HISTORIC AND DESIGN REVIEW COMMISSION

HDRC CASE NO: 2023-380
ADDRESS: 8623 OLD CORPUS CHRISTI RD
LEGAL DESCRIPTION: NCB 10923 BLK 4 LOT N 58.17 FT OF 3A
ZONING: R-6, H
CITY COUNCIL DIST.: 3
DISTRICT: Mission Historic District
APPLICANT: Walter Carrasco
OWNER: SANDOVAL ARCELIA
TYPE OF WORK: New construction of a 1-story, single-family structure
APPLICATION RECEIVED: September 08, 2023
60-DAY REVIEW: November 7, 2023
CASE MANAGER: Rachel Rettaliata

The applicant is requesting a Certificate of Appropriateness for approval to construct an approximately 1,355-square-foot 1-story, single-family structure.

Historic and Design Review Commission
Design Review Committee Report

2 SITE PLAN
1/8" = 1'-0"

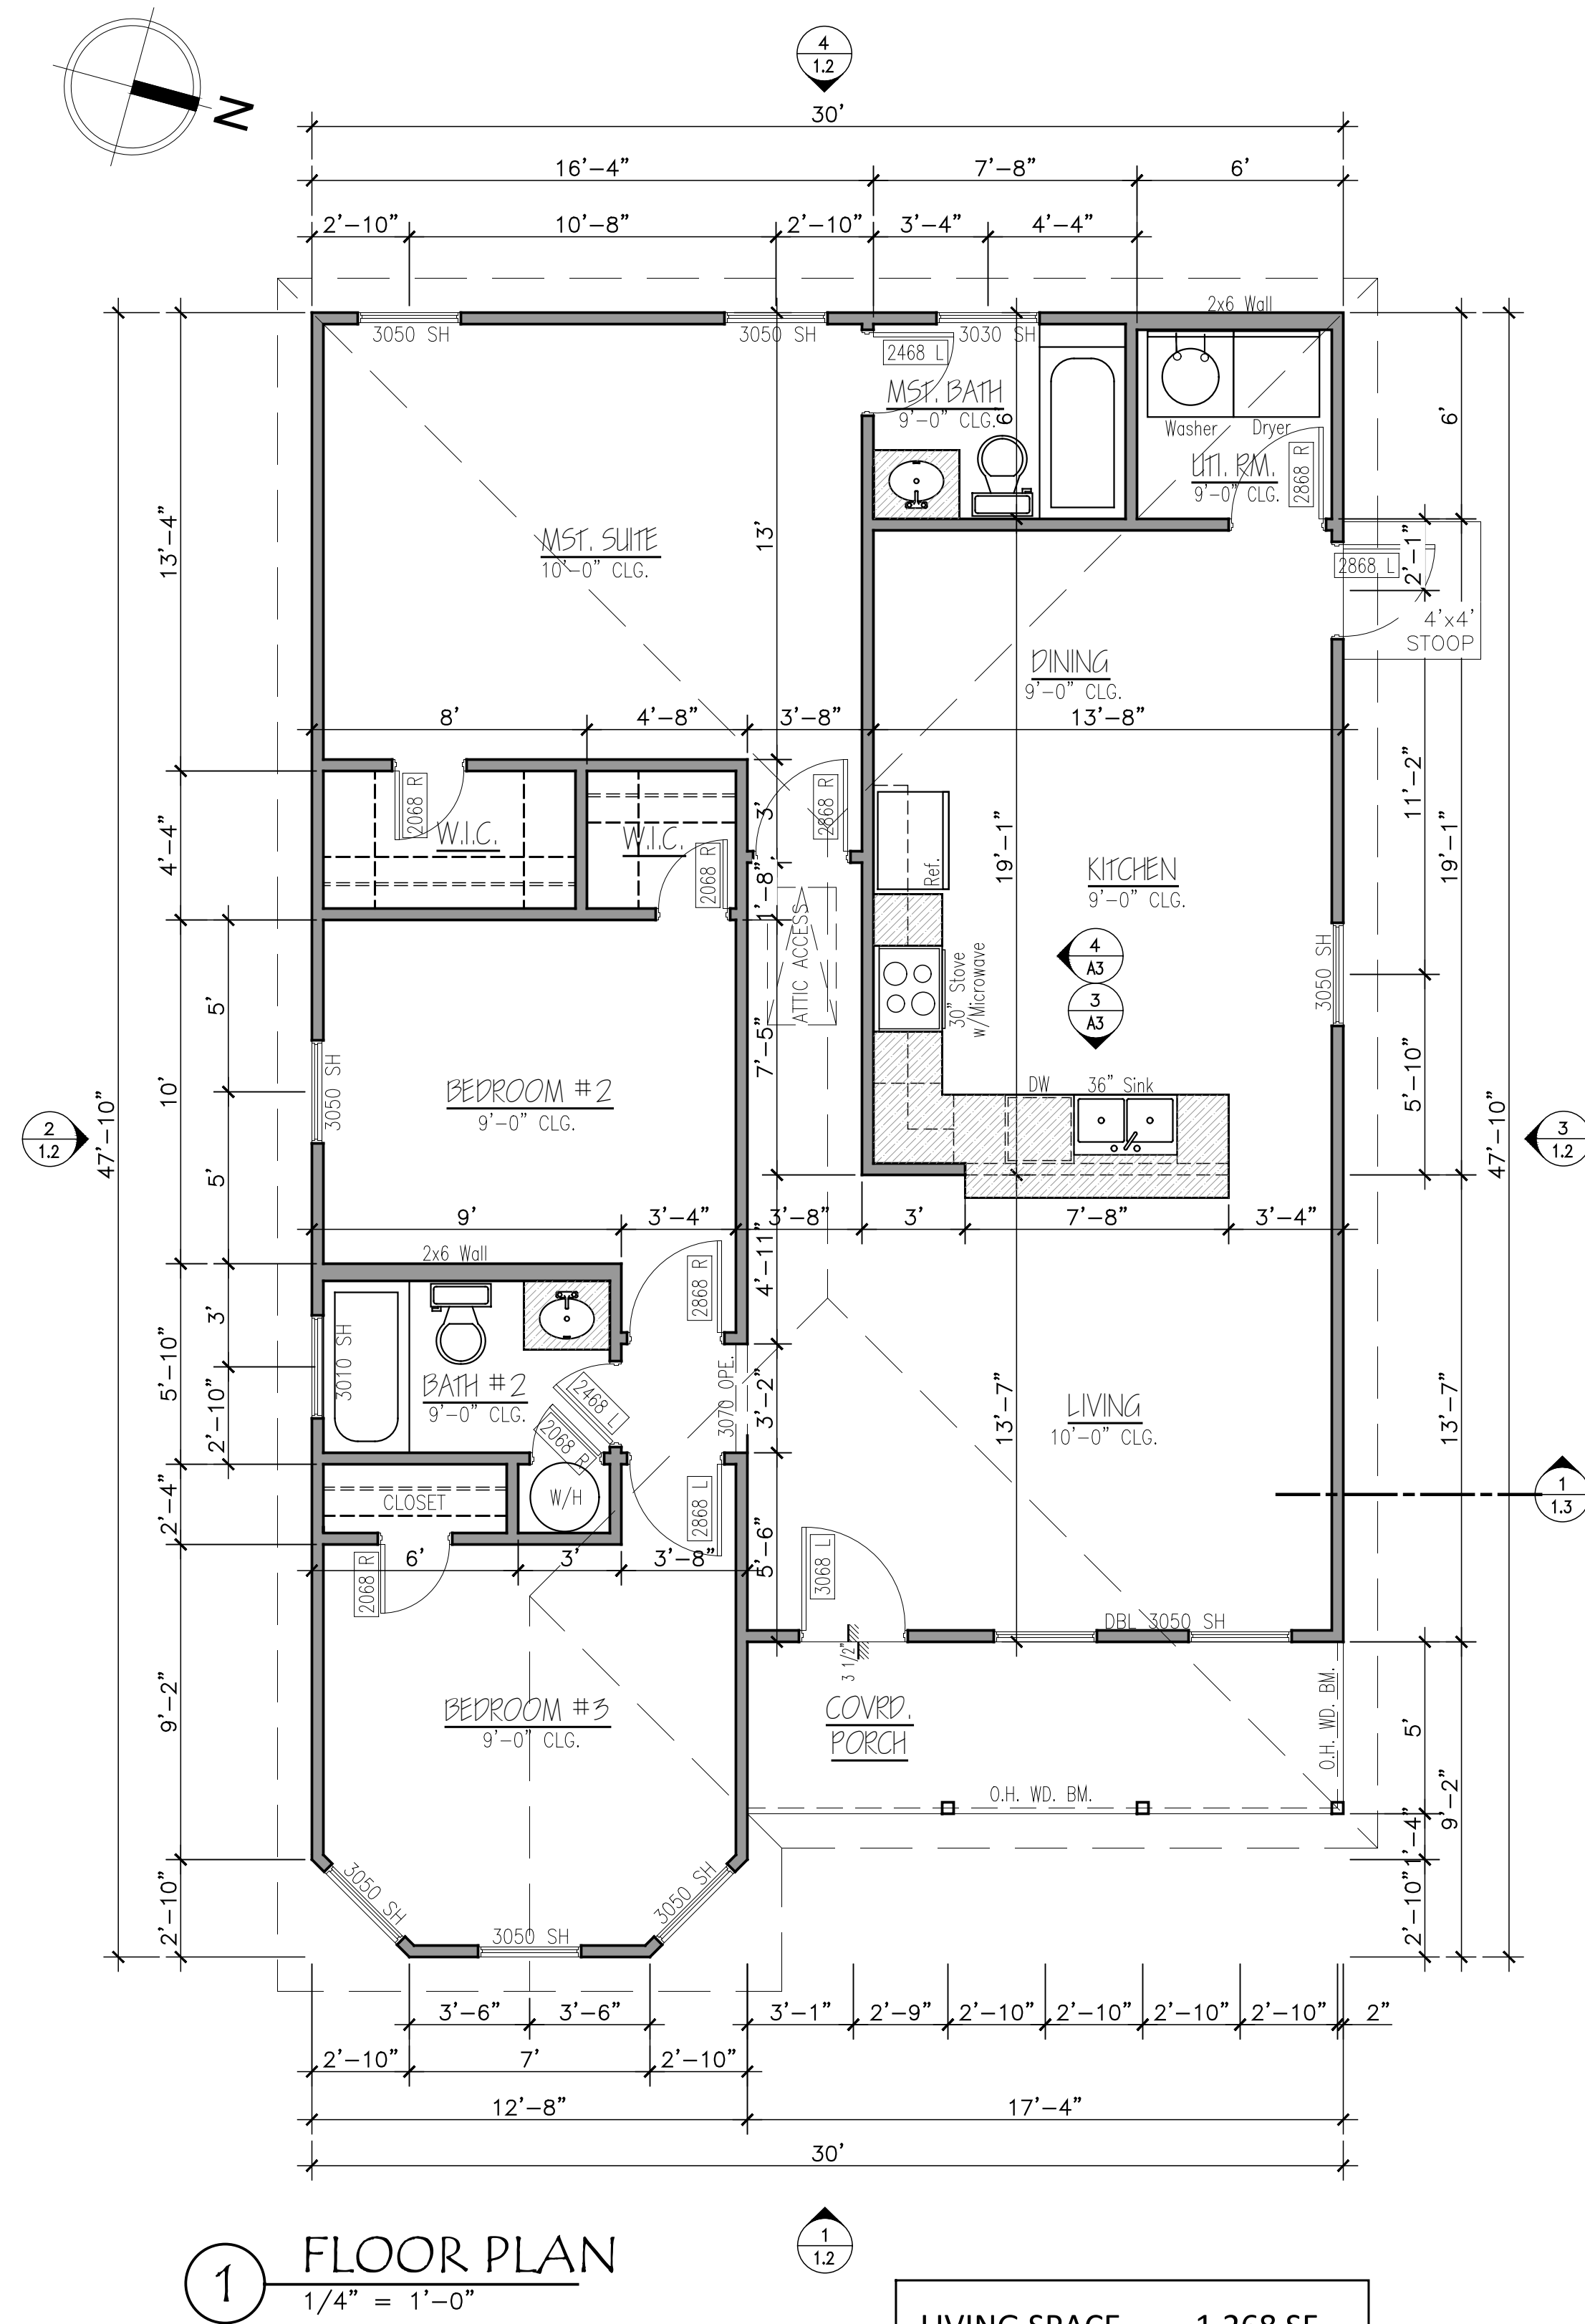
- e. SETBACKS & ORIENTATION – According to the Guidelines for New Construction, the front facades of new buildings are to align with front facades of adjacent buildings where a consistent setback has been established along the street frontage. Additionally, the orientation of new construction should be consistent with the historic examples found on the block. The applicant has noted that the proposed setback from the property line along will total 35 feet. At this time, the applicant has not provided the setback dimensions for the adjacent structures; however, the neighboring primary structures feature setbacks of approximately 20-25 feet from the property line. Staff finds that the applicant should submit a setback diagram to staff for review.

- o. **WALKWAY** – The applicant has proposed to install a fully concrete walkway from the public right-of-way to the front entry. Staff finds the proposal generally appropriate but finds that the applicant should submit the walkway dimensions to staff for review showing that the walkway does not exceed 4 feet in width.

- r. **DRIVEWAY** – The applicant has noted a fully concrete driveway width of 12 feet. The Guidelines for Site Elements notes that driveways within historic districts should be limited to ten (10) feet in width. Staff finds that the applicant should reduce the width of the proposed driveway to 10 feet and the proposed driveway apron should not exceed 12 feet in width.

- i. That the applicant submits a setback diagram showing the setbacks of adjacent structures to staff for review and approval prior to the issuance of a Certificate of Appropriateness based on finding e.
- ii. That the applicant submits the foundation height for the proposed new construction, showing that the foundation height will be within one (1) foot of the adjacent structures to staff for review and approval prior to the issuance of a Certificate of Appropriateness based on finding h.

- vi. That the applicant submits an updated site plan showing that the walkway will not exceed 4 feet in width and that the driveway will not exceed 10 feet in width to staff for review and approval prior to the issuance of a Certificate of Appropriateness based on findings o and r.

JF: One thing that would be helpful information to provide, would be on your site plan – your setback is 30 feet from the property line – if we knew what the building line was on the adjacent houses.

2 SOUTH ELEVATION
1/4" = 1'-0"

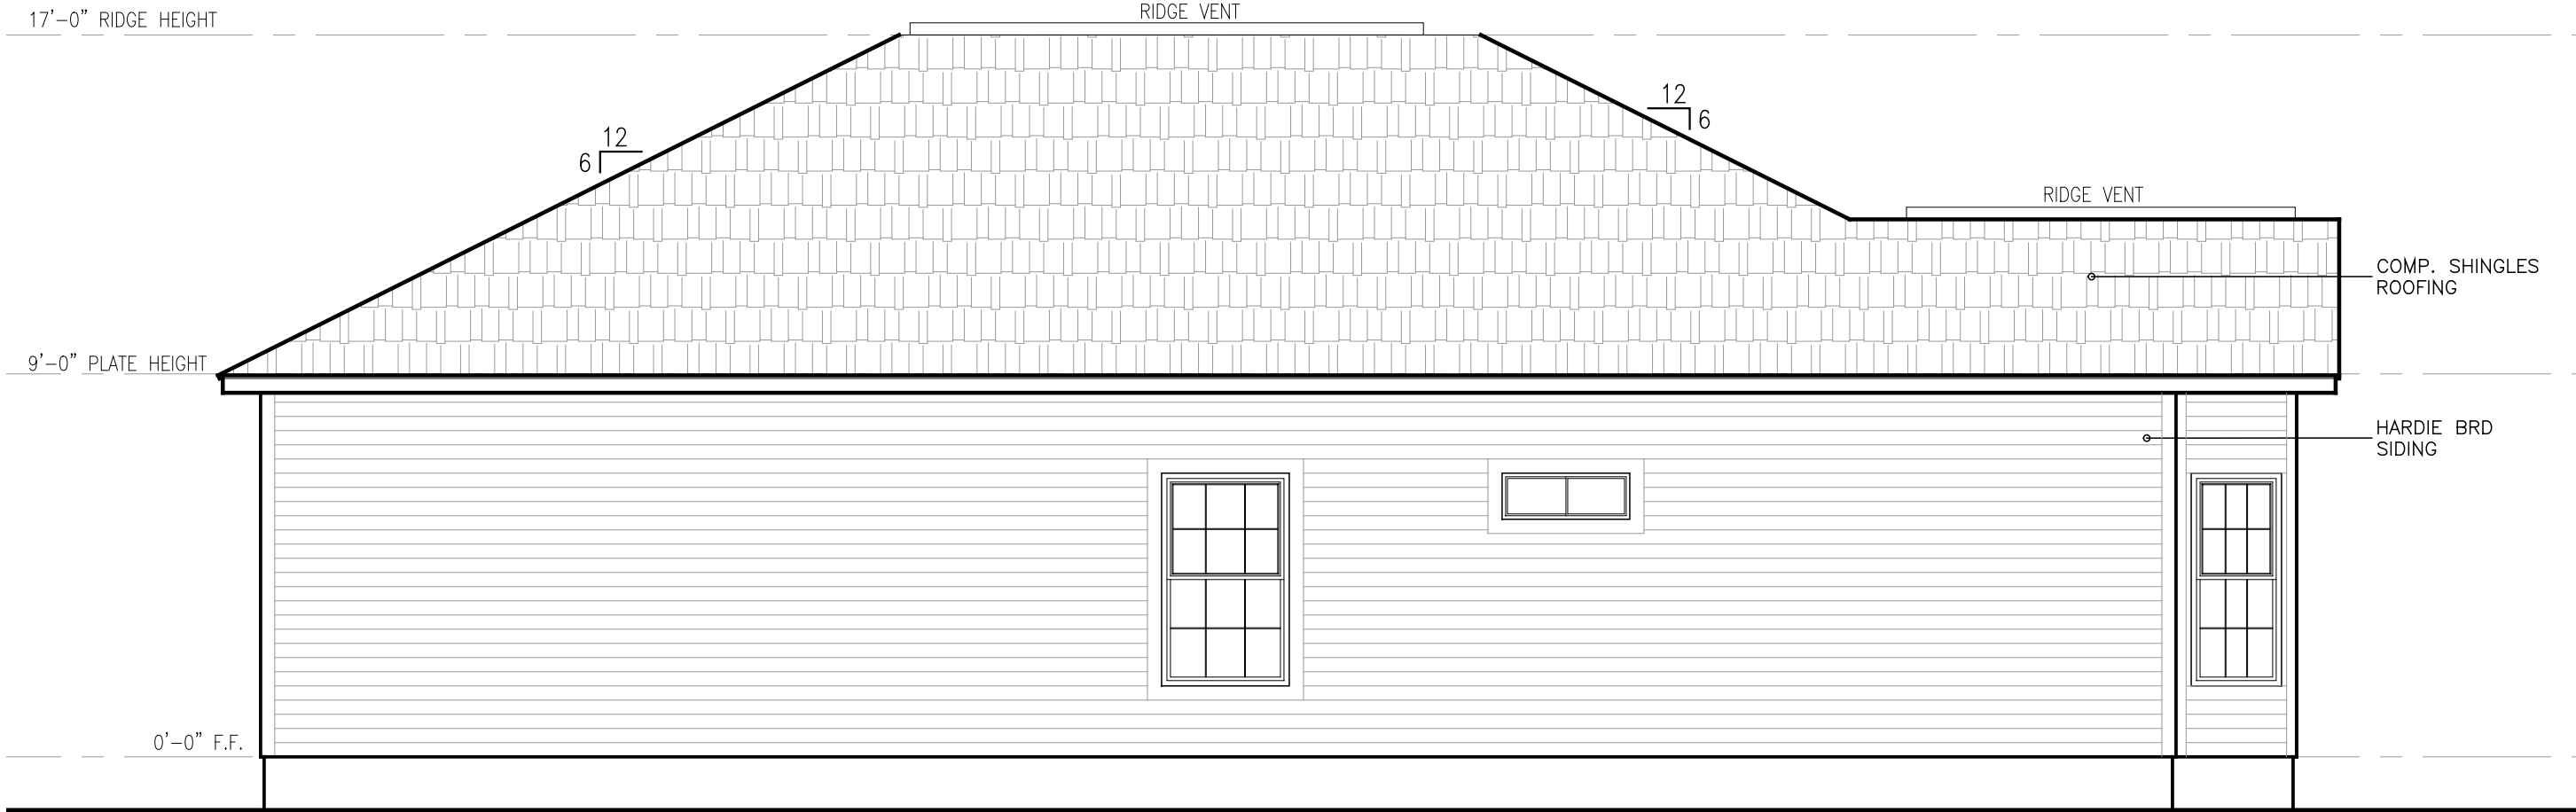
- m. **WINDOW & DOOR OPENINGS** – Per the submitted documents, the applicant has proposed window profiles and fenestration patterns that are generally consistent with those found historically within the district and the Guidelines for New Construction. Guideline 2.C.i for New Construction states that new construction should incorporate window and door openings with a similar proportion of wall to window space as typical with nearby historic facades. Windows, doors, porches, entryways, dormers, bays, and pediments shall be considered similar if they are no larger than 25% in size and vary no more than 10% in height to width ratio from adjacent historic facades. Staff finds that the applicant should increase the fenestration on the north and south elevations to be more consistent with the Guidelines.

- v. That the applicant increases the amount of fenestration on the north and south elevations based on finding m and submits updated elevation drawings to staff for review and approval prior to the issuance of a Certificate of Appropriateness.

Jeffrey Fetzer: The size and scale of the house is appropriate for the neighborhood. On the north and south elevations, is it possible to add more windows? On the north elevation maybe if the window became a double window?

WC: Yes, we can also add additional windows in the master bedroom of the south elevation.

JF: Depending on how your master suite lays out, maybe you could have windows on either end of the room. At least one window on the south wall of the master suite will help with the overall design.

JV: I had the same concern, just the fenestration pattern on the house. One window on the north elevation and one on the south elevation would be golden. What is the style of window that looks like a little rectangle?

WC: That will provide the most light and privacy. I already redlined the plan so I could provide the additional windows and send the plans again.

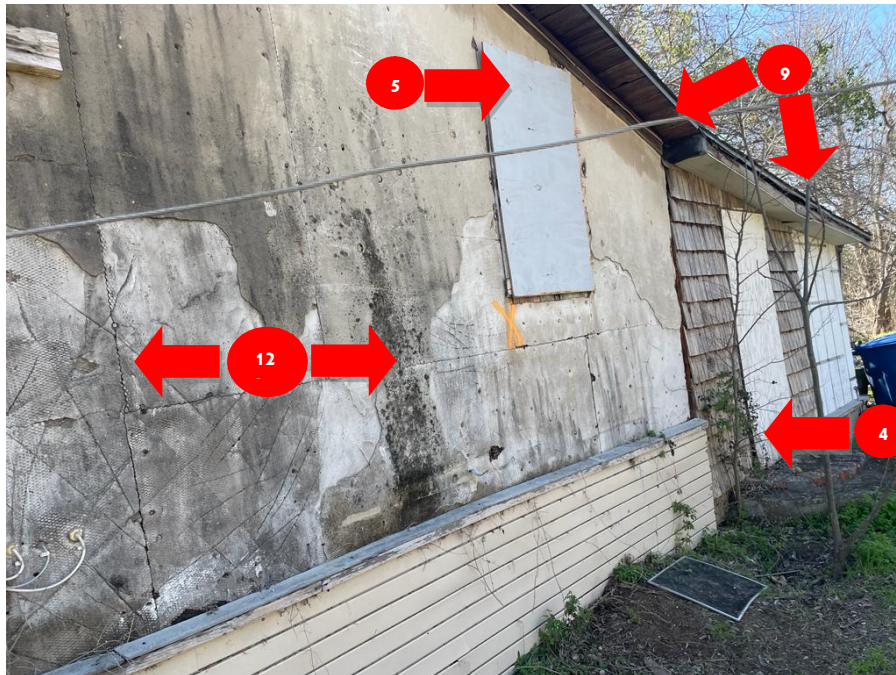
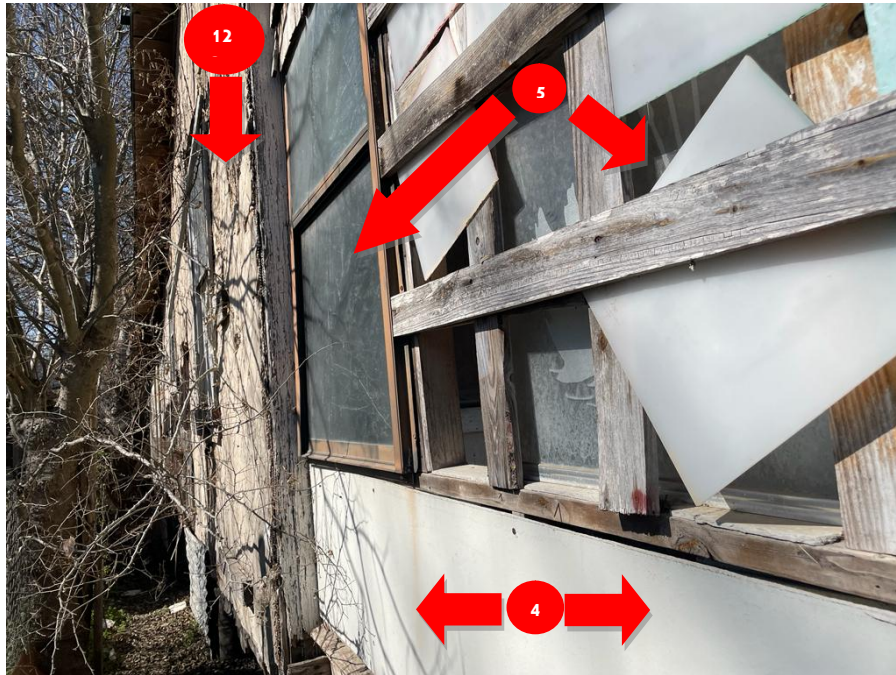
1. Existing wood deck needs to be replaced with foundation post replaced in new IBC code applicable.
2. Skirting below existing finish floor needs to be replaced.
3. Front elevation railings required to be replaced to meet code.
4. Existing siding requires to be replaced and be replaced by one pattern siding. existing siding needs to be removed.
5. Existing windows need to be removed and replaced with required windows meeting the code.
6. Existing structure has several types of roofs and requires new roof.
7. Observation of foundation footings requires replacement with new engineered design.
8. Structure requires new main framing that will meet the current code requirements.
9. Exterior fascia needs to be replaced and installed properly.

10. Existing structure does not have proper wall waterproofing barrier with base flashings. Existing porch needs new sub floor replacement.
11. Existing stucco requires replacement and to be replaced with selected siding.
